RE: Section 5 Declaration R534/19 Lee Villa, Sundays Well, Cork

PLANNER'S REPORT Ref. R534 /19		Cork City Council Culture, Community and Placemaking
Application type	Section 5 Declaration	
Description	<i>Whether Proposed Renovation Works to Property Known as Lee Villa, Sundays Well Road in Cork City are exempted development</i>	
Location	Lee Villa, 21 Sundays Well Road, Cork	
Applicant	Jack Coughlan	
Date	30/08/2019	
Recommendation	<i>Is Development and Is Not Exempted Development</i>

Section 5 Planning Statement
**Lee Villas,
Sundays Well, Cork City**

Google 3D Mapping

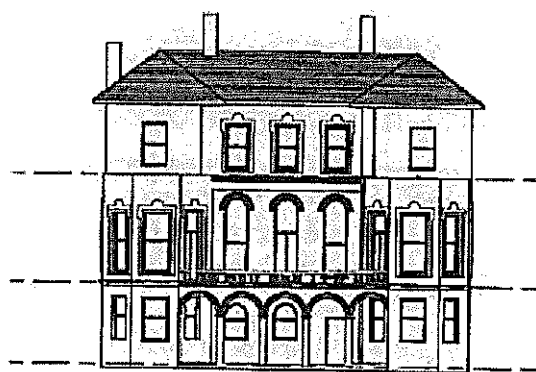
I note that the removal of the bay windows will result in a decrease to the floor area of the ground and first floors. Further the removal of the balcony will also result in the removal of the arcade supporting structure.

Existing South Elevation

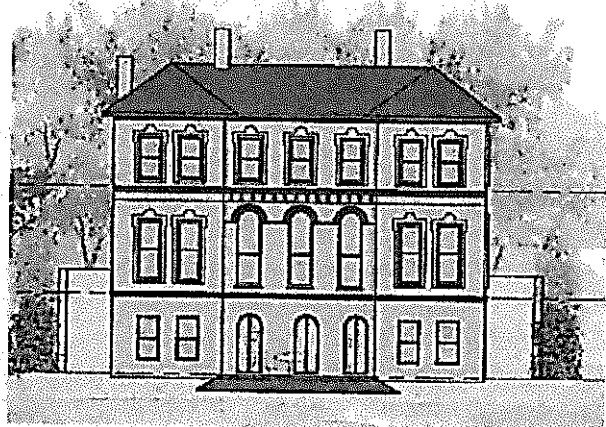
I note that the second floor of the existing south elevation does not accord with the building, as constructed, in particular the window arrangement above the bay windows.

The photograph provided, in the Section 5 Planning Statement, shows that the southern façade of the original building built c.1820. It is noted that the proposed alterations to the current structure will not reinstate this earlier façade as the c.1880 alterations included the addition of an additional storey which is not proposed to be removed.

The extent to which the structure was altered by the addition of the additional storey, bay windows, arcade supported balcony and other decorative elements materially changed the character in the 1880's. The proposed alterations will remove the two storey bay windows, the balcony and the arcade, removing historic materials which form key elements of the late 19th century elevation.

The removal of historical fabric will materially change the character of the building. It is concluded therefore the proposed works will materially alter the external appearance and hence character of the structure. The change in character of the building, it is considered, will render the appearance inconsistent with the current 1880's character of the structure.
